SUBJECT: Savannah River Site's Responses to the Regulatory Comments on the R-Area Groundwater (NBN) Biennial Effectiveness Monitoring Report in Support of R Area Operable Unit (U) January 2017 through December 2018 (SRNS-RP-2019-00267, Revision 0, June 2019) SEMS Number: 95

TECHNICAL REVIEW COMMENTS

SRS Responses to EPA comments on the R-Area Groundwater (NBN) Biennial Effectiveness Monitoring Report in Support of R Area Operable Unit (U), January 2017 through December 2018, SEMS Number: 95, SRNS-RP-2019-00267, Revision 0, June 2019, Savannah River Site NPL Site, South Carolina

CR Figure 1. R-Reactor Water Table History

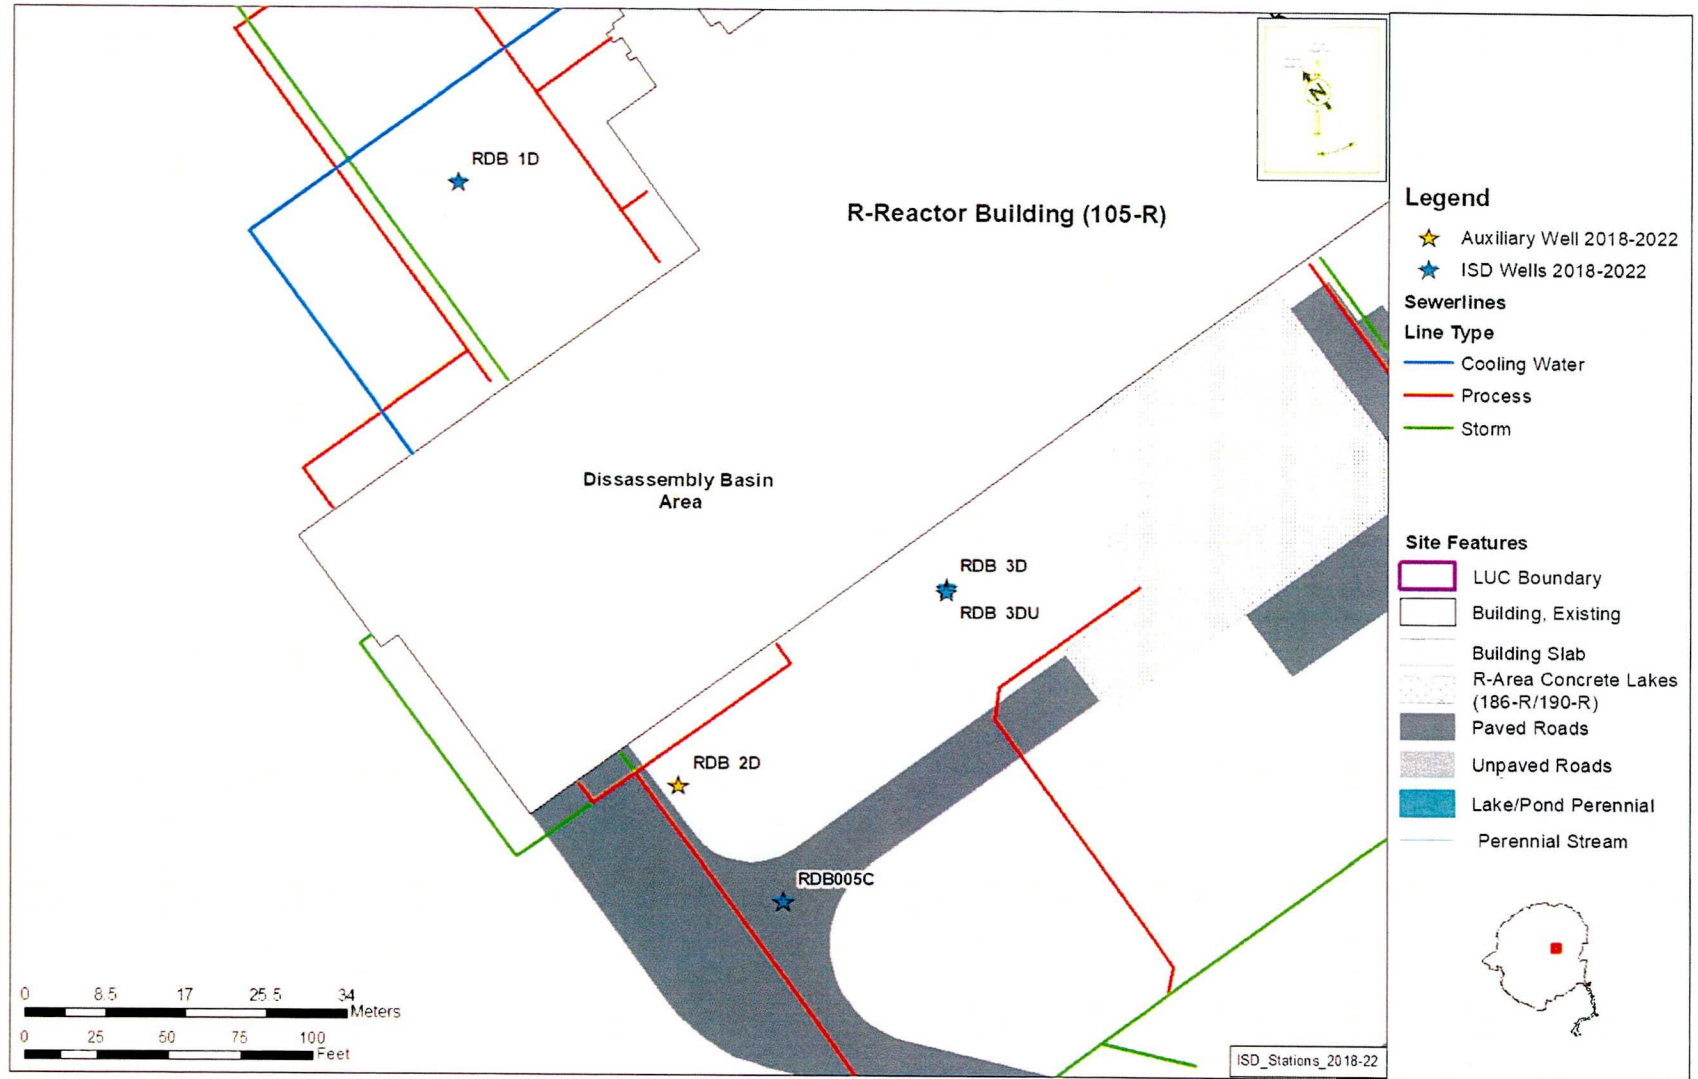
4. The text in Section 5.2 (ISD Conclusions) states the 2017 increase in tritium and carbon-14 at well RDB 3D may be due to mobilization of a small shallow legacy spill near the disassembly basin, related to the recent high-water table levels. The EMR also notes that

greater than average rainfall was measured at the Savannah River Site during 2017 and 2018. As such, it is recommended the annual monitoring event be scheduled during seasons of high rainfall when high water table conditions exists to ensure representative groundwater samples are collected to monitor potential source mobilization near the disassembly basin.

Long-term trends indicate that precipitation is fairly uniform throughout the year, with drought or wet periods lasting years as reflected by the attached comment response (CR) Figure 1 R-Reactor Water Table History. Due to the shallow water table and low permeability sediments in the water table aquifer, RAOU wells exhibit greater short-term water level fluctuations than many other SRS water table wells, but these short-term changes (typically +/- 2 feet) are not expected to significantly impact contaminant levels as compared to the increase of 5 to 7 feet as observed between 2012 and 2018. As such, SRS believes the groundwater samples collected around the R-Reactor Disassembly Basin are representative of groundwater conditions.

EMR Figure 1. Annual ISD Monitoring Wells (2018 through 2022)

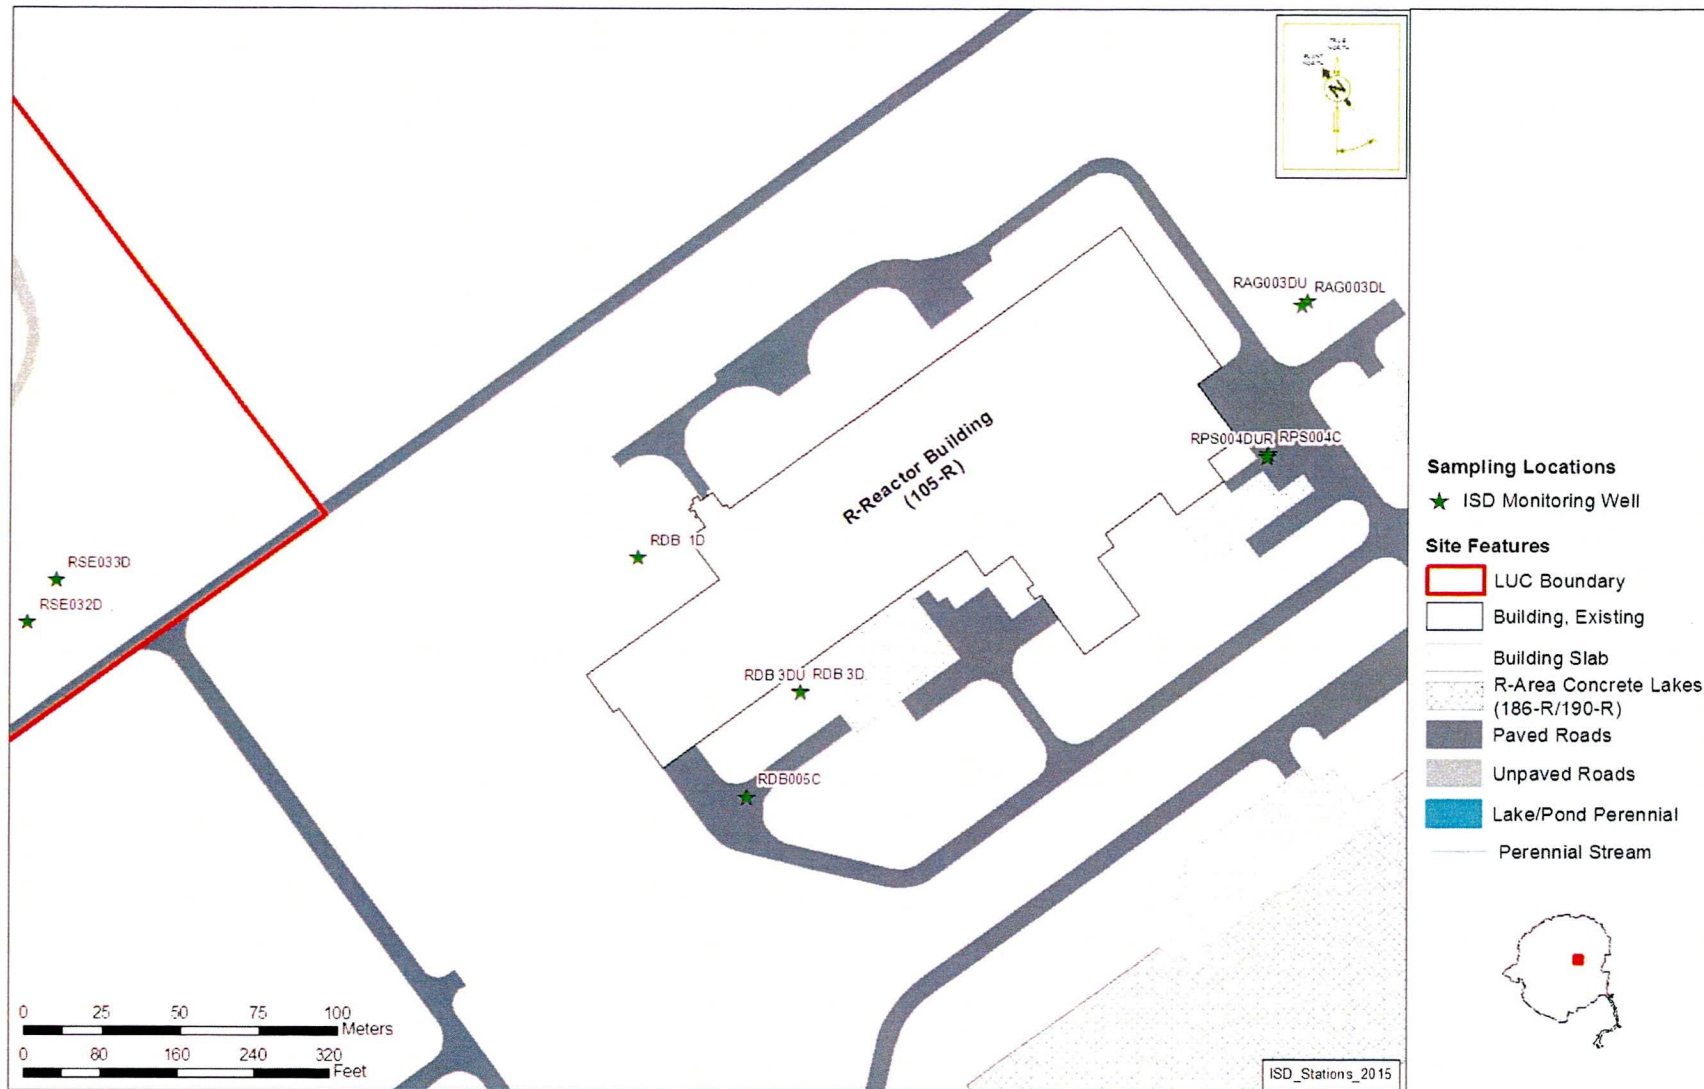
1. In section 3 on page 6, the text states well RDB 2D will be an auxiliary ISD monitoring well during the five year time period (i.e., 2018 through 2022). However, the EMR does not discuss or state what conditions would warrant the sampling of auxiliary ISD monitoring well RDB-2D. As such, the purpose of the auxiliary well is not clear. Additionally, this well is not depicted in Figure 4 (ISD Monitoring Wells 5-Yrs). Revise the R-Area Groundwater (NBN) Biennial Effectiveness Monitoring Report in Support of R-Area Operable Unit (U), January 2017 through December 2018, SEMS Number: 95, SRNS-RP-2019-00267, Revision 0, dated June 2019 (EMR) to address this issue to ensure the purpose and location of auxiliary well RDB-2D is clearly documented.

Excluding RDB003DU, well RDB 2D is the closest well horizontally to RDB 3D (EMR Figure 5) and RDB 2D has the same screen zone as RDB 3D (EMR Table 1). Well RDB 2D was not included in the original ISD monitoring network, which is why it was not included in EMR Figure 4 and labeled as an “Auxillary ISD Well”, but it may be useful in determining the extent of C-14 in the groundwater if it is more than just an isolated spill detected at well RDB 3D. It will be identified as a “Temporary ISD Well” to better clarify its function in the next RAOU EMR, as EMRs are considered secondary documents and not typically revised by agreed protocols.
